HDC Work Permit Staff Review

Property address: 100 W Michigan

Proposed work: New façade windows on the second and third floors.

CUSTOMER SIGNOFF DRAWING

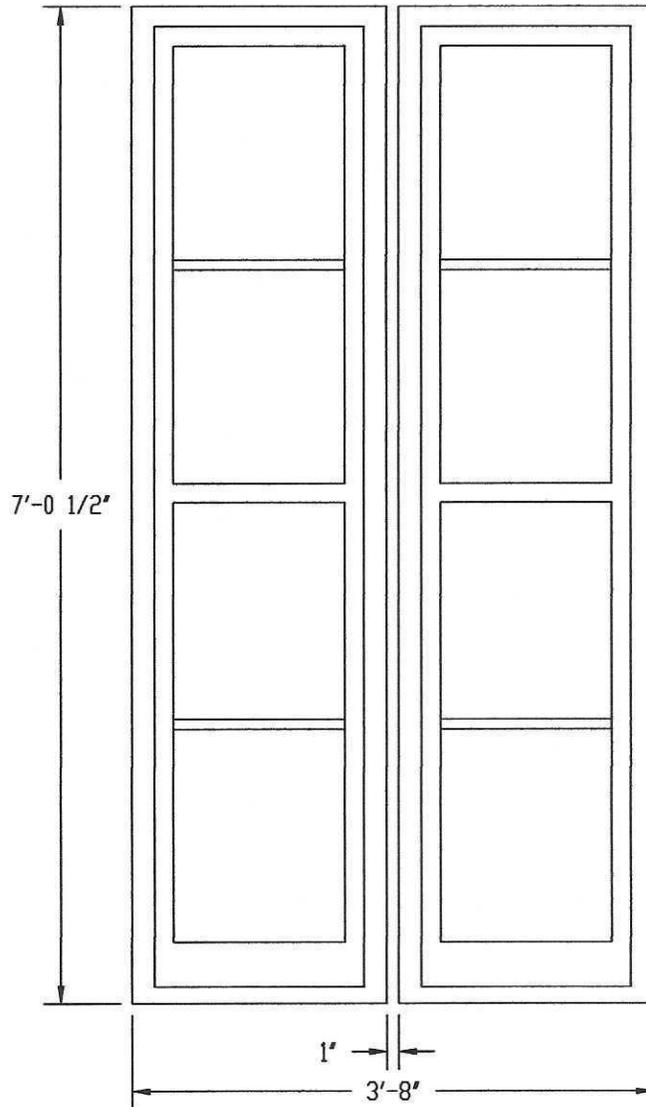
2. The widow replicates the original central mullion flanked by two double-hung sashes. The mutin grille pattern is replicated as well.
3. The original windows were arched. The arched opening was discussed at the May 26 meeting as a study item. The HDC seemed open to having a rectangular window placed within the remaining arched openings.

5. Several types of grill installations and trim patterns were submitted with the spec sheets. The applicant is to clarify to the HDC which will be implemented.
